REVIEWER 2

General comments

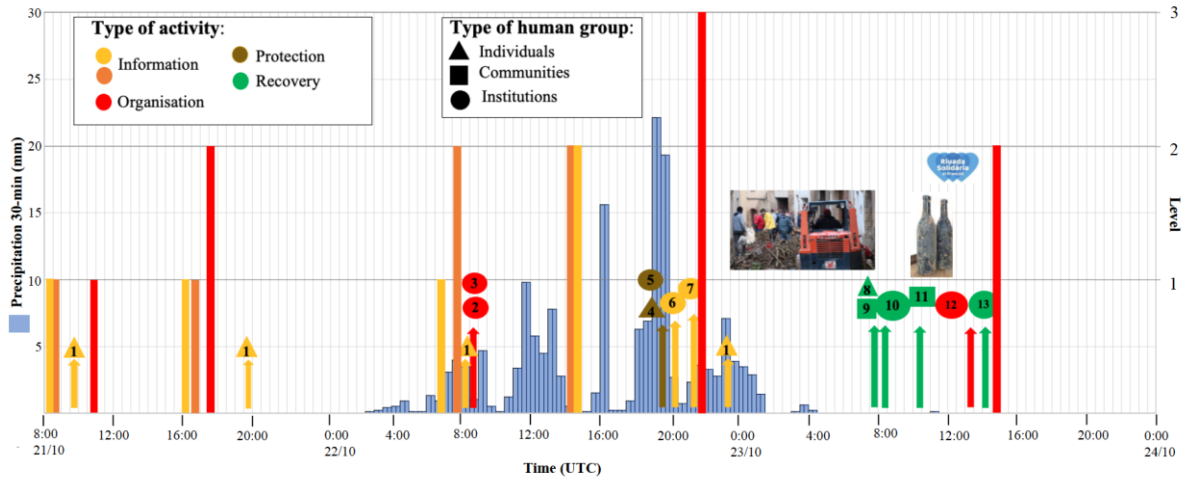
The term “social response” is too broad and should be more specific. Do you mean management actions?

Effectively, the term “social response” covers a broad spectrum of social actions, encompassing from the warning procedure to responses at individual, group and organizational levels. The warning procedure itself involves several actions such as, monitoring, forecasting strategies, and the planning of management measures. In this study, the authors opted for the more generic term “social response” because the manuscript not only evaluates management activities but also describes human responses and citizen perceptions during the flash flood.

The revised version breaks down the extensive social response into two main components, according to Creutin et al. (2009): management activities and human responses. The former includes three different types of actions: information, organization, and protection. The latter encompasses human responses within three groups: Individual, communal and institutional. Consequently, the title of new section 5.2.1 now incorporates the more precise terms “risk management” and “human response”. In addition, a more quantitative analysis has been conducted based on information gathered during the FLOOD-

UP FRANCOLÍ citizen campaign in the Conca de Barberà council. New Table 7 and Figure 12 provide a more detailed account of the types of actions and the timeline followed during the course of the flash flood.

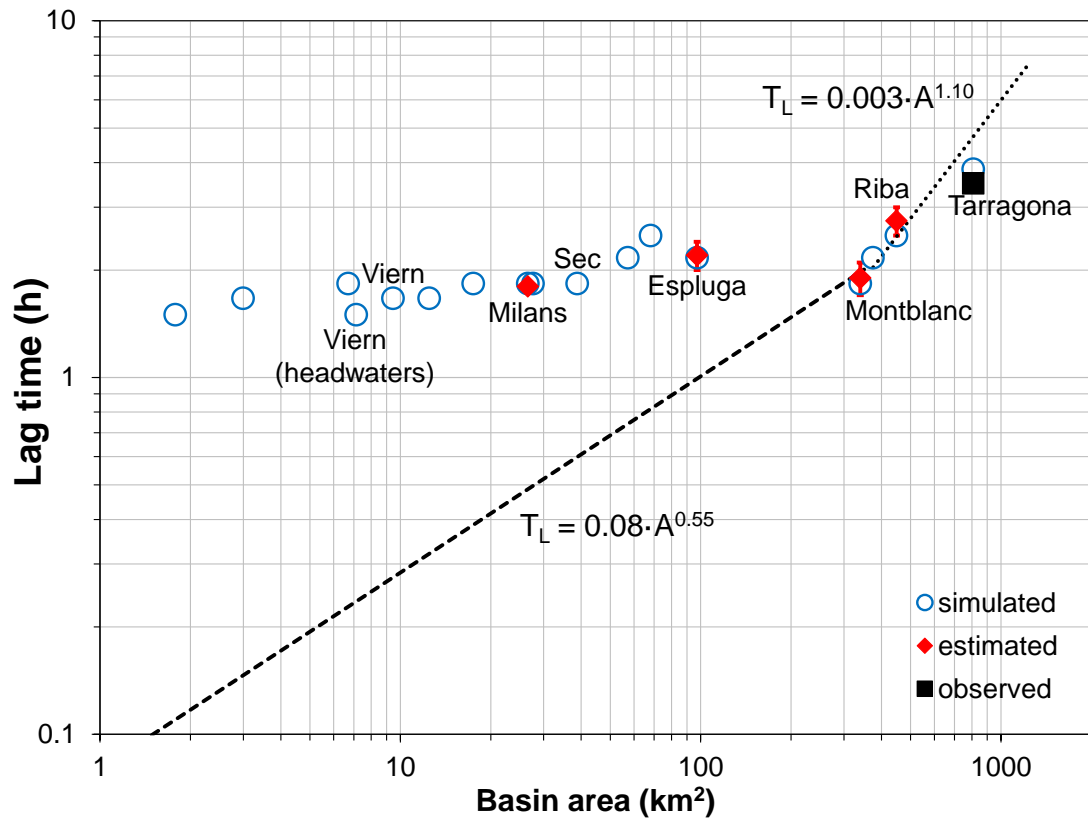
Figure 11 is odd. Why do you have “estimated” uncertainties only on a few data points? This should be for all simulated values. Why do we have only one “observed” value? How can lag time be even observed?

As mentioned earlier, Figure 11 has undergone modifications to enhance clarity. For ease of graphical interpretation, the names of the river sections with available estimates and observations have been incorporated. In addition, the simulated lag times for the 17 river sections serving as control points in the hydrological simulation have been included for comparison. The uncertainties associated with the estimated lag times stem from the ranges of time of peak discharge estimated at the different hydrometric sections, as shown in Table 1, and derived from the post-event field campaign by Martín-Vide et al. (2023). Times of peak discharge were estimated through interviews with eyewitnesses. Their associated uncertainties are shown as vertical bars

Acknowledging that the lag time cannot be directly observed, the authors recognize that the use of the term “observed” might be misleading in this context. In this study, the lag time is computed as the temporal difference between the centre of mass of the rainfall hyetograph (i.e. the rainfall centroid) and the timing of peak discharge. Therefore, the “observed” lag-time is derived from the automatic stream-gauge data available at the catchment outlet and the rainfall fields obtained from the weather radar, justifying its label as observed. An explanatory sentence has been added to the caption of Figure 11 to prevent confusion.

Figure 10. Observed and radar-driven runoff simulations for the control and sensitivity test experiments and the 22 October flash flood at the Tarragona flow-gauge in the Francolí basin.

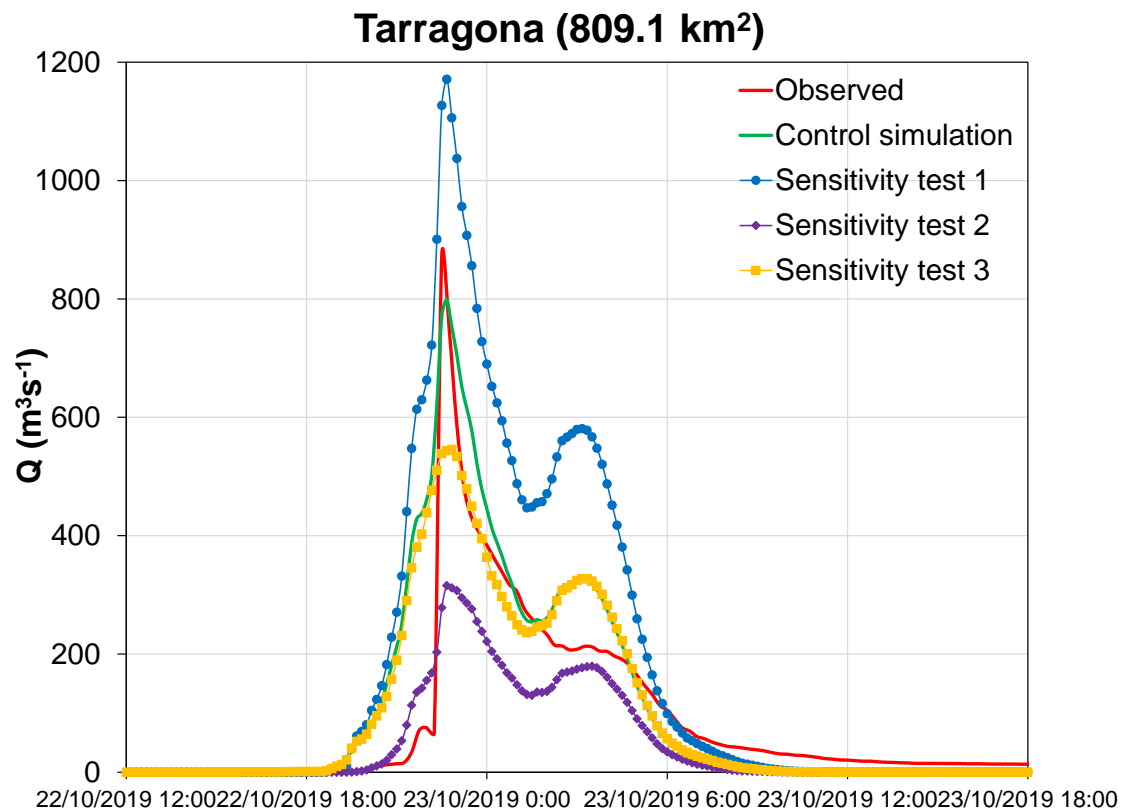
Section 4.3.3: Add a table and show the sensitivity scenarios.

New Table 5 and Figure 10 present the results obtained from conducting the sensitivity tests

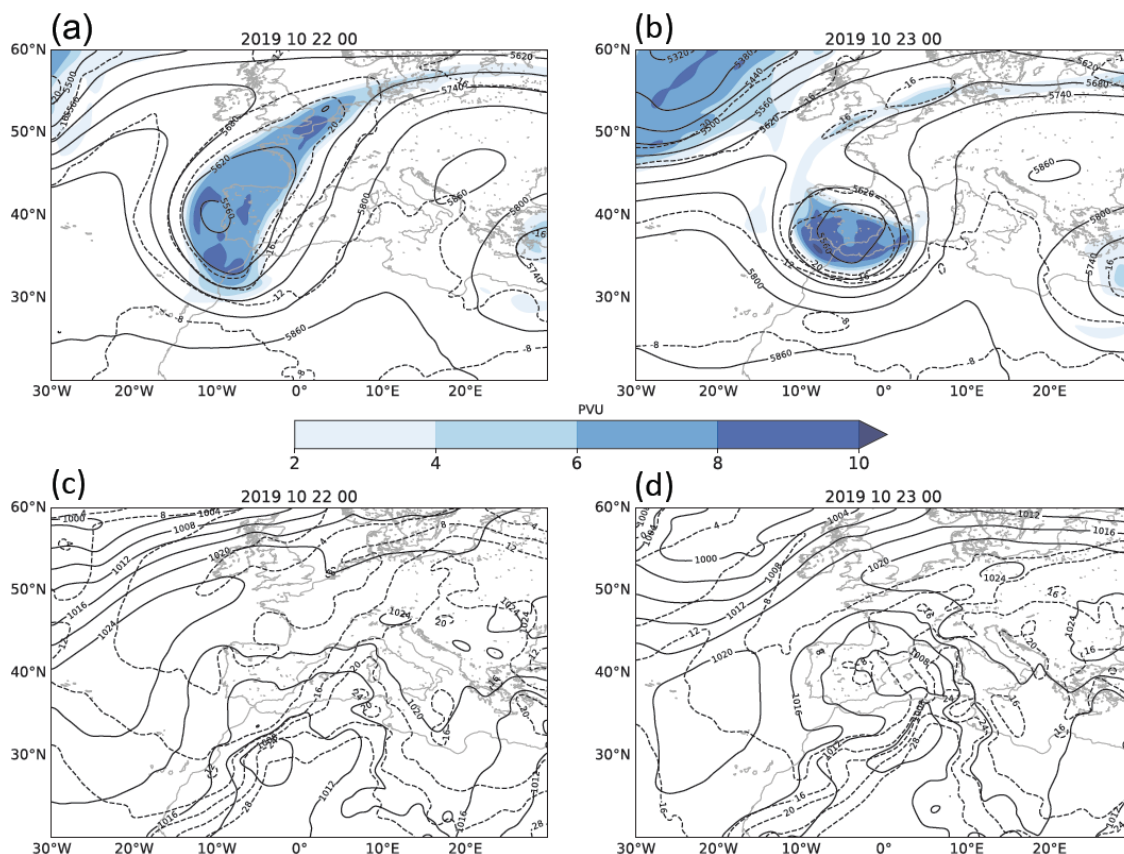
Figures 1-3 should be improved by considering the size, alignment etc.

Figures 2 and 3 have been improved in response to the reviewer’s concerns. Nevertheless, the authors maintain that Figure 1 adheres to the standard configuration found in scientific literature when introducing a study region. Typically, a top-left figure showcases the main features of the region, while a central figure illustrates the main features of the catchment of interest.
